Access Compliance Report

Public Rights-of-Way

Intersection ID: 14486	Main Street: MAIN_ST	Cross Street: AVANT_ST	Location: S
ADA ID: CDF046EA627D	Ramp Type: PerpDiag	Initial Pass/Fail: Fail	Overall Compliance: No
		Severity Score: 17.5

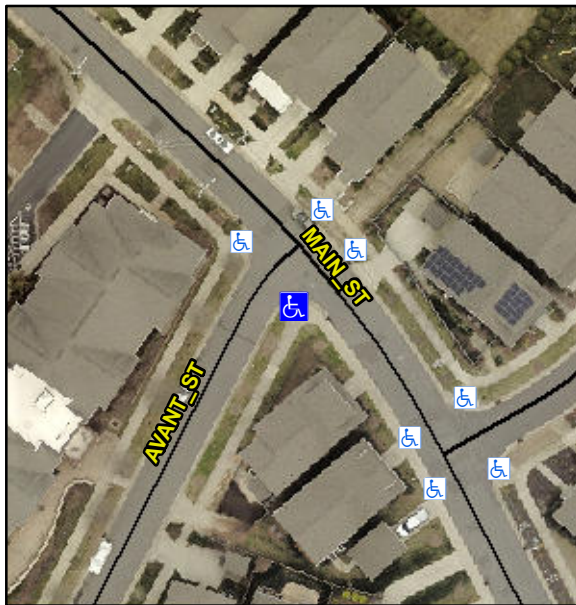
Not Found, R304.5.1

Compliance	Description	Data	Compliance	Description	Data
N/A	Ramp Length (in)	61.0	Yes	Ramp Slope (%)	7.7
No	Ramp Width (in)	35.0	Yes	Ramp XSlope (%)	0.7
N/A	Flare Type LT	N/A	N/A	Flare Type RT	N/A
N/A	Flare Slope LT (%)	N/A	N/A	Flare Slope RT (%)	N/A
N/A	Flare Traversable LT?	N/A	N/A	Flare Traversable RT?	N/A
N/A	Landing Length (in)	N/A	N/A	DWS Provided?	N/A
N/A	Landing Width (in)	N/A	N/A	DWS Contrast?	N/A
N/A	Landing Slope (%)	N/A	N/A	DWS Length (in)	N/A
N/A	Landing X Slope (%)	N/A	N/A	DWS Full Width?	N/A
N/A	Landing Curb? (Y/N)	N/A	N/A	DWS Offset (in)	N/A
N/A	Shared Landing?	N/A			
N/A	Gutter Ponding?	N/A	N/A	Gutter Slope (%)	N/A
N/A	Gutter Lip Ht (in)	N/A	N/A	Gutter X Slope (%)	N/A
N/A	Painted X Walk1?	No	N/A	Painted X Walk2?	No
	X Walk 1 Direction	To NE		X Walk 2 Direction	To NW
N/A	X Walk 1 Width (in)	N/A	N/A	X Walk 2 Width (in)	N/A
	X Walk 1 Slope (%)	4.1		X Walk 2 Slope (%)	0.9
	X Walk 1 X Slope (%)	1.4		X Walk 2 X Slope (%)	1.1

Remove & Replace Curb Ramp With Two New Directional Ramps or Equivalent.
